July 15, 2016

**BOARD OF COUNTY COMMISSIONERS
ORANGE COUNTY, FLORIDA**

**ADDENDUM NO. 3 / IFB NO. Y16-776-PH
INTERNATIONAL DRIVE POTABLE WATER BOOSTER PUMP STATION**

DRAWING NO.:
C105
SHEET: 11 OF 49

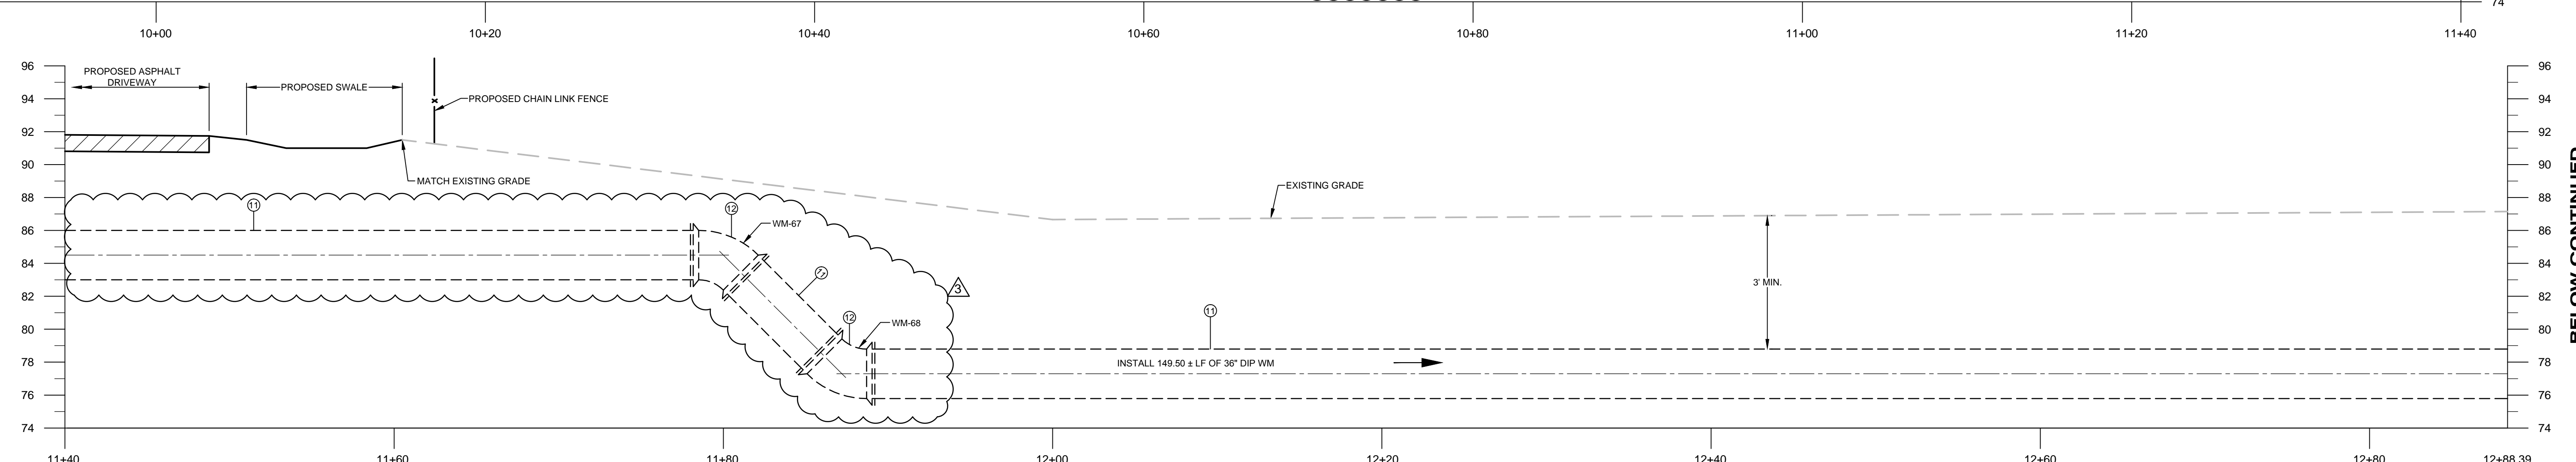
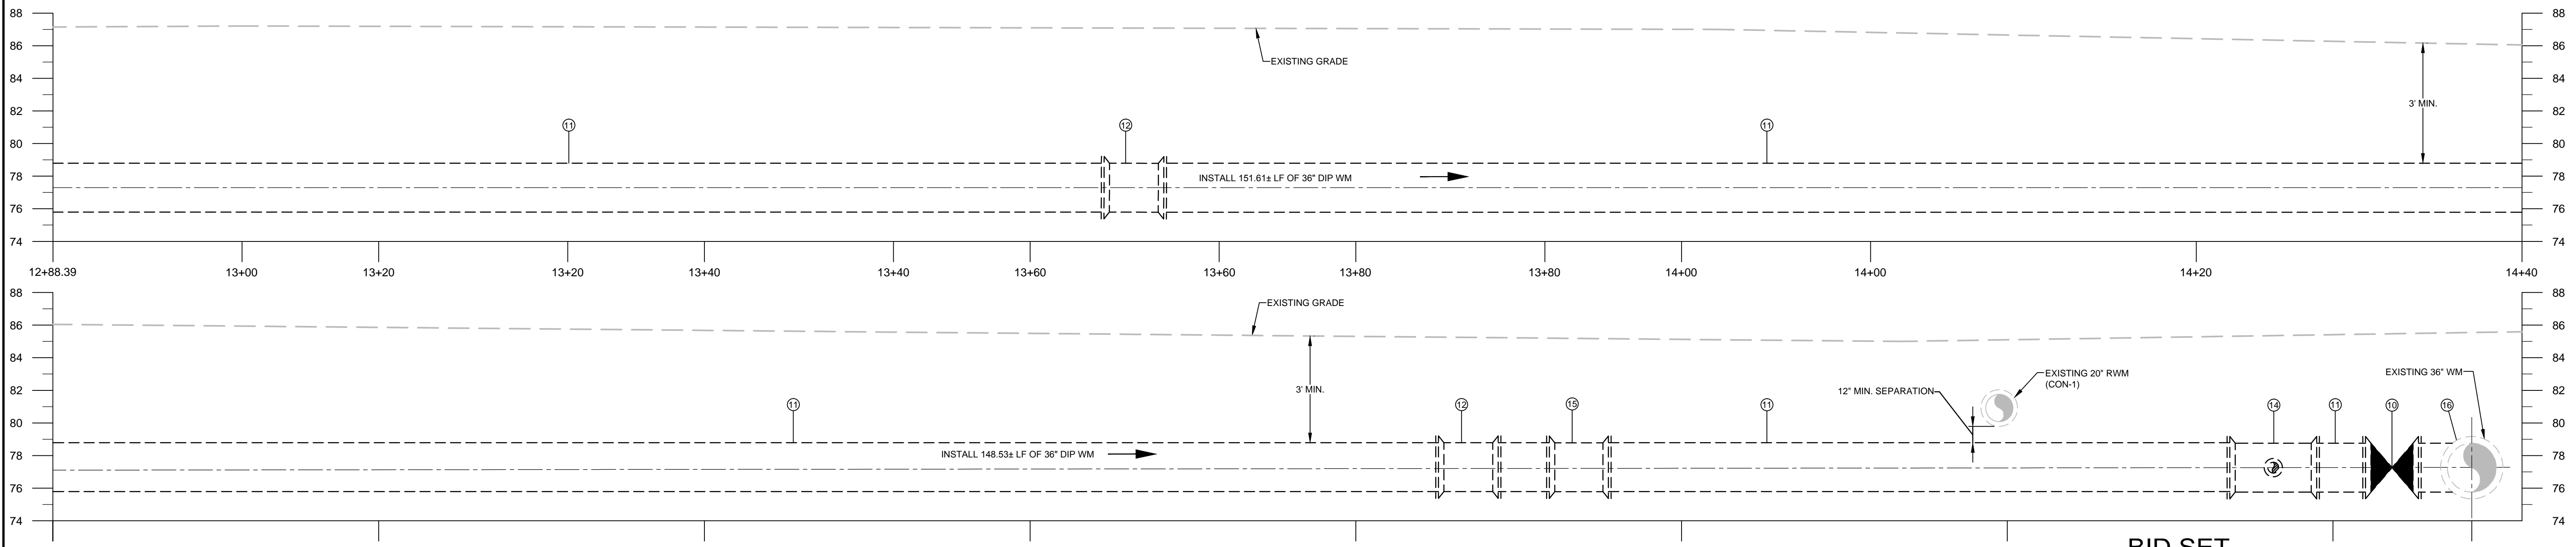
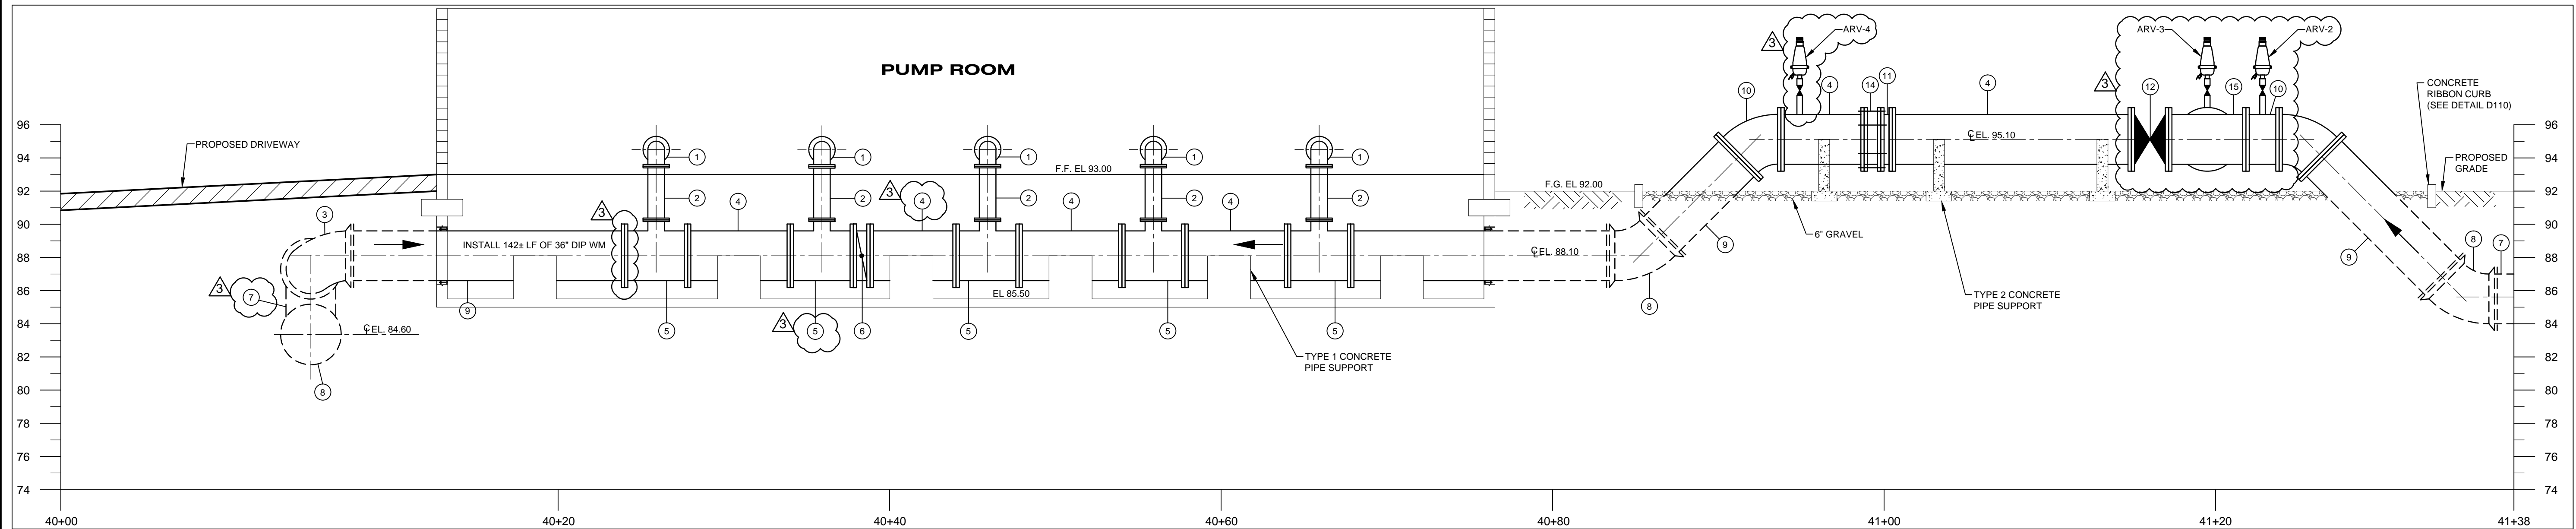
1. Q: Please clarify the 36" flanged valves? C103 calls for butterfly valves; C105 and C106 call for gate valves.

- Added two additional 36" 45 degree bends to the discharge piping (see Drawing C105 and C107).
- Added size, manufacturer and model numbers to injection quills. See clouded revision to item 30 on the Pipe, Fitting, and Equipment Legend on Drawing C103.

- Added size, manufacturer and model numbers to air release valve. Relocated air release valve to new tee. See clouded revision and added Item 37 on the Pipe, Fitting, and Equipment Legend on Drawing C103. Also, see revisions to Drawing C105 showing new air release valve location.

The 36" flanged gate valves are labeled correctly on revised sheets C105 and C106.

A: The 36" bypass pipe and 36" check valve and all associated fittings and appurtenances have been revised to be installed above grade. Attached are the revised Drawings associated with this change (Drawings C103, C104, C105, C106, and X100).

BID SET
SCALE: 1" = 5'
DRAWING NO.:
C108
SHEET: 14 OF 49

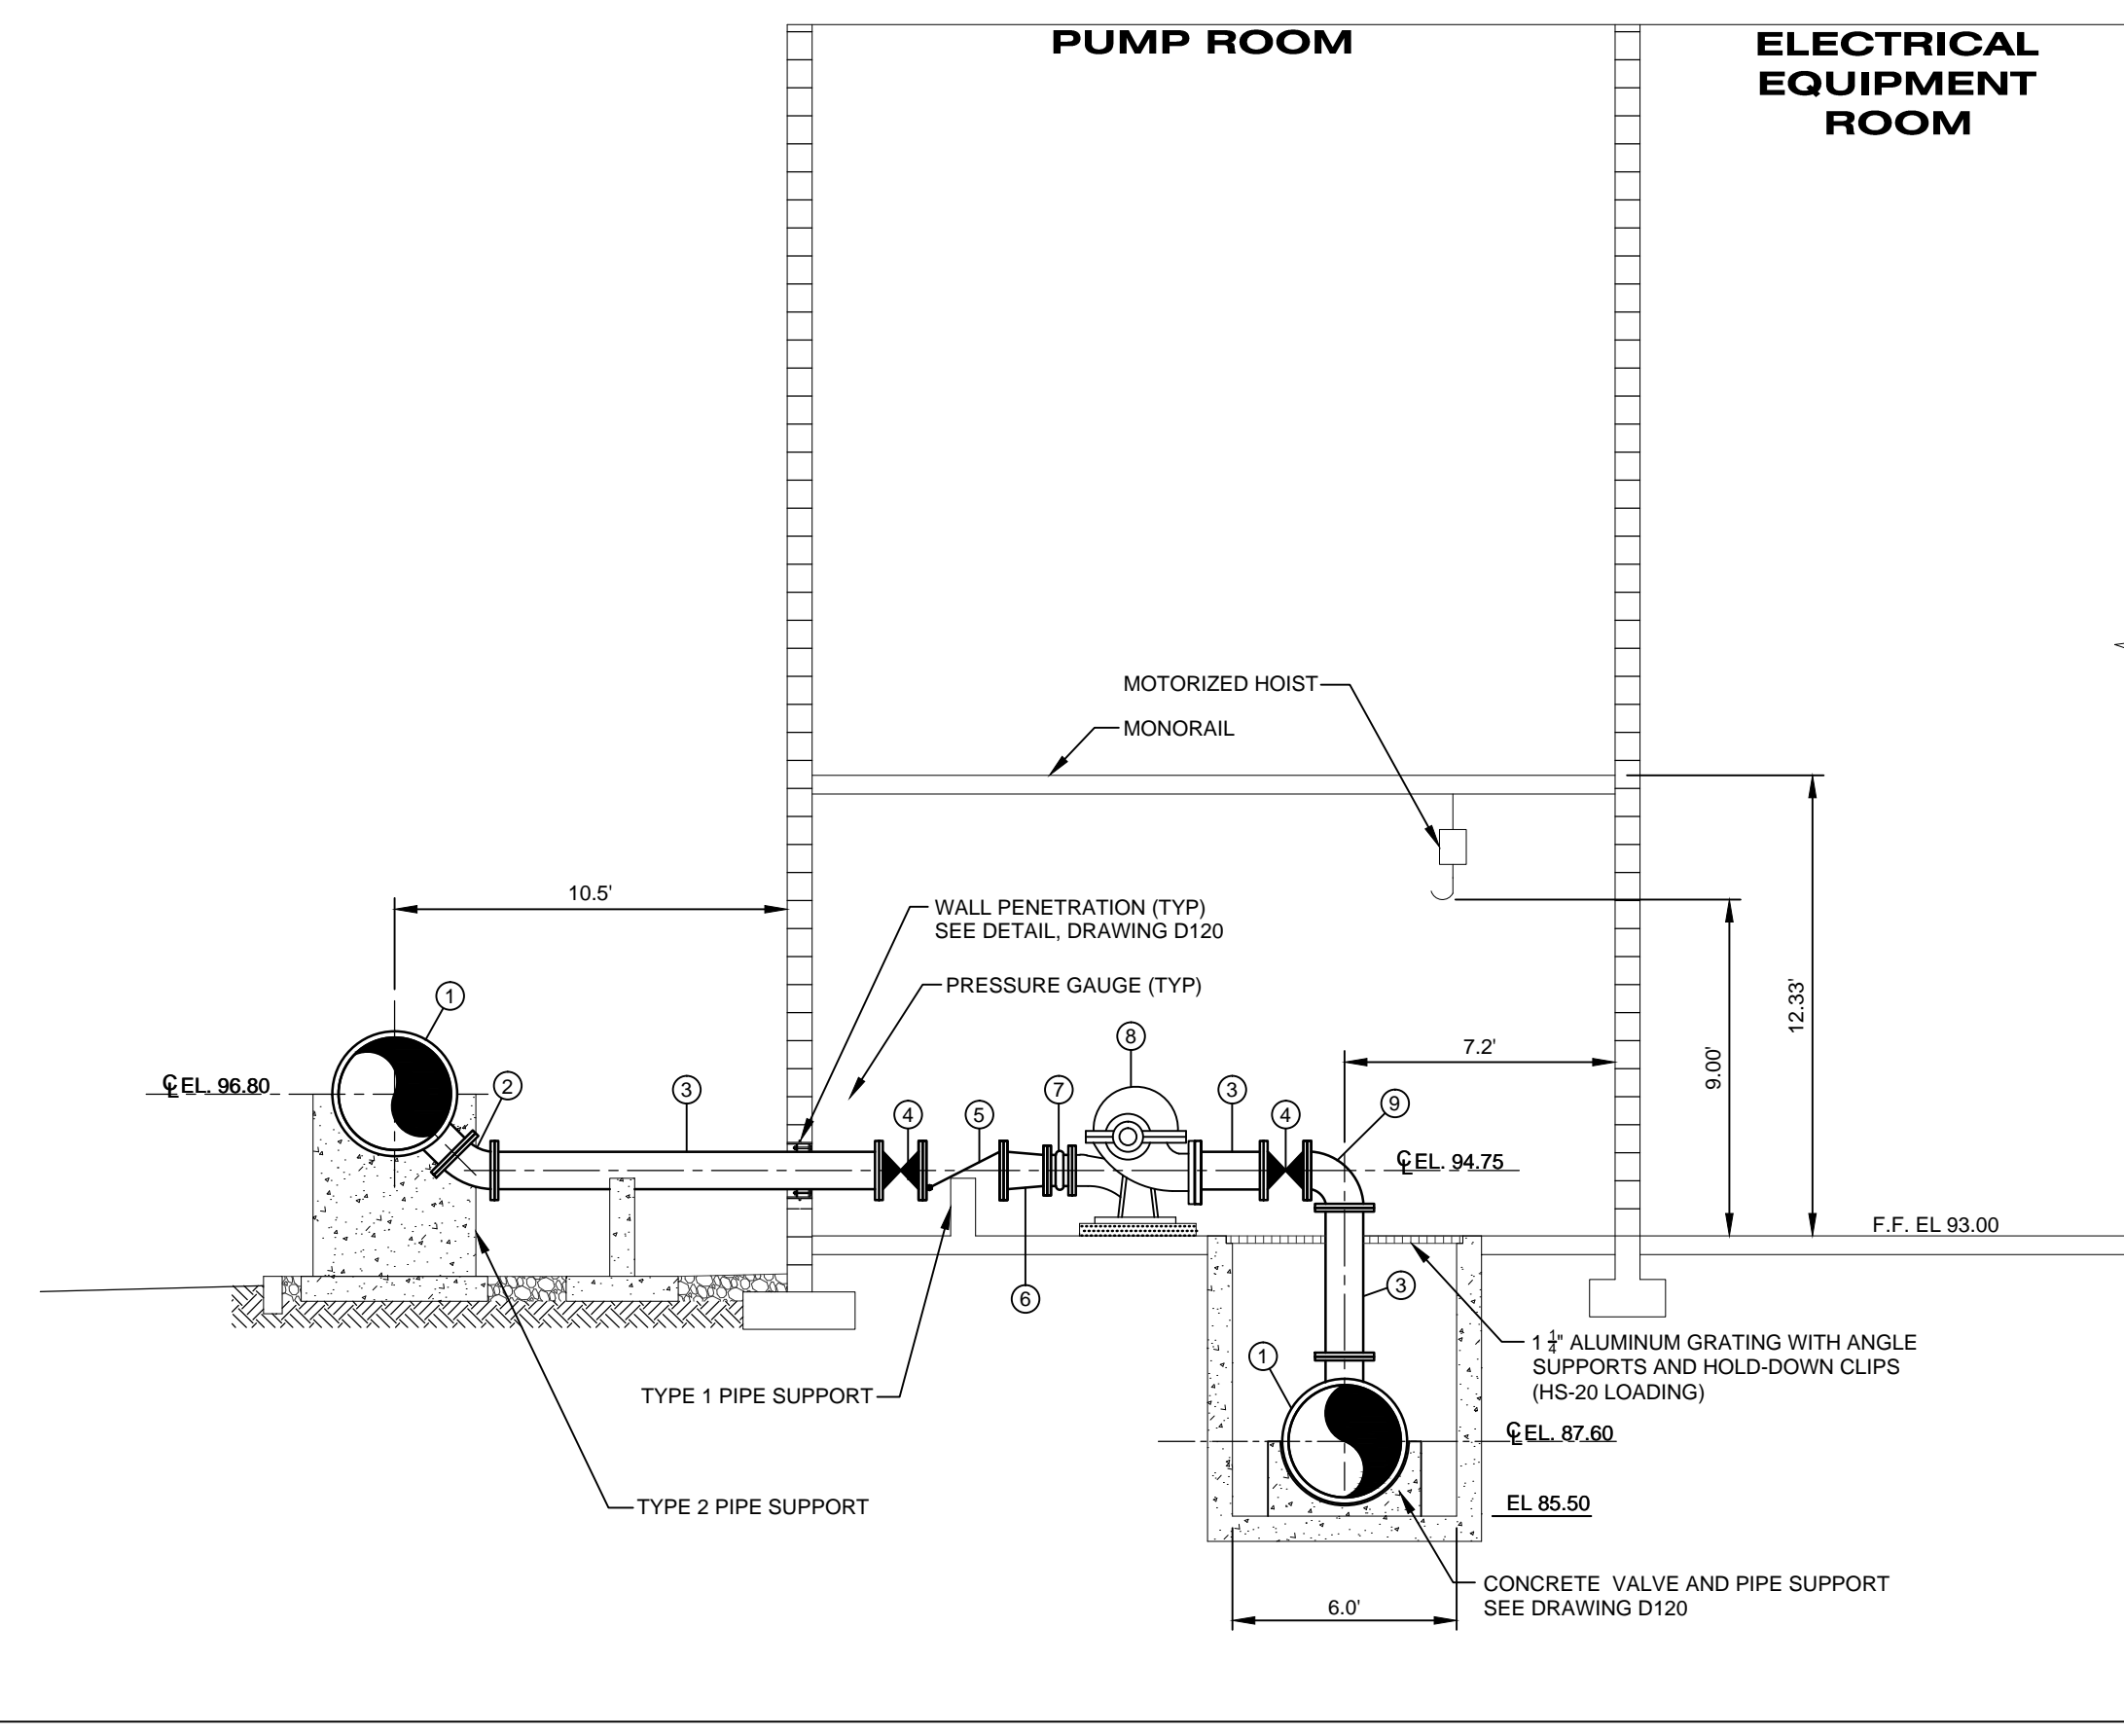
- Modifications to the holding tank dimensions and manufacturer in order to meet FDOH permit requirements. See clouded revisions to Drawings C103 and C108.
- Updates to tags, identification numbers, callouts, and fitting locations where clouded. See clouded revisions to Drawings C103, C104, C105, C106, C107, C108, and X100.
- Deleted 36" blind flange callout (Item 28 on the Pipe, Fitting, and Equipment Legend on Drawing C103) and deleted associated Identification Number WM-29. See clouded revisions to Drawings C103 and X100.
- Revised 36" bypass pipe and 36" check valve above grade. Several other revisions to nearby fittings were also revised to be above grade. See clouded revisions to Drawings C103, C105, and C106.
- Added gravel and ribbon curb around modified 36" bypass pipe and check valve that were raised above grade. See revisions to C103.

RIBBON CURB DETAIL
SCALE: NONE

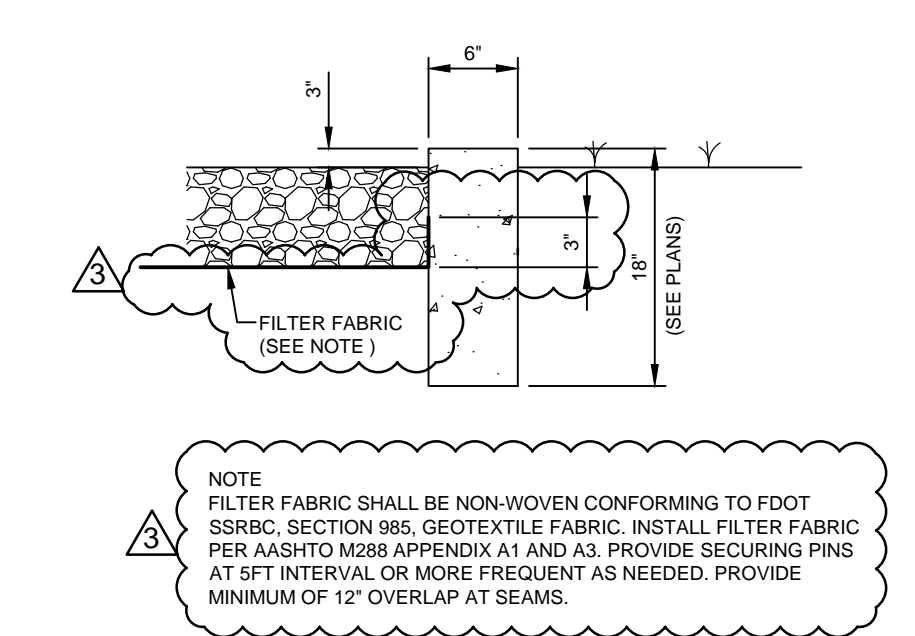
9. Q: On sheet C102 the curb is shown as 12”. On the detail on sheet D110 the “ribbon curb” is shown as 18”. Please advise.

- Added filter fabric beneath gravel as shown on the Ribbon Curb Detail on Drawing D110.
